PEER REVIEW  
LETTER

Application: Long Sands Village; James M. Paolini  
(Tax Map 44 Lot 38)

**Site Plan and Subdivision Review – Elderly Housing**

Review Status: Continued for Preliminary Plan review.

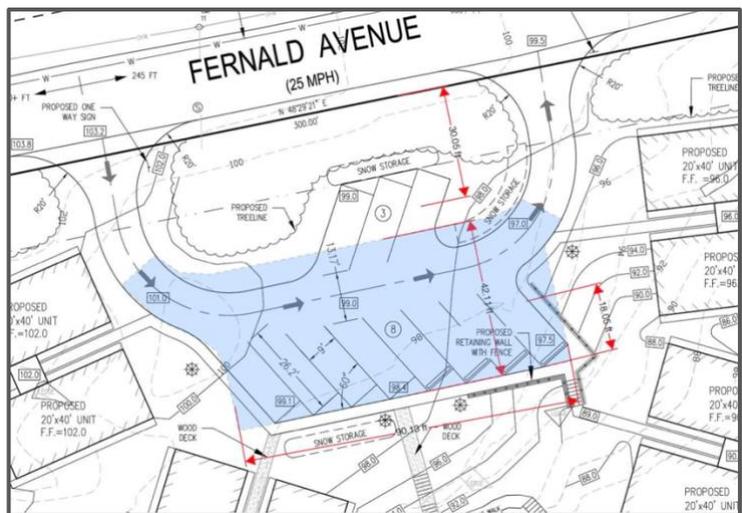
5. An alternative to the three parking spaces in the buffer yard and to the less efficiently spaced angled parking proposed, is a small row of ten perpendicular spaces. This alternative would only require a 42-foot swath rather than the proposed 58 feet resulting in only a net loss of one parking space, leaving more than 30 feet of buffer area undisturbed adjacent to an important area that needs to be effectively screened (See image to the right).
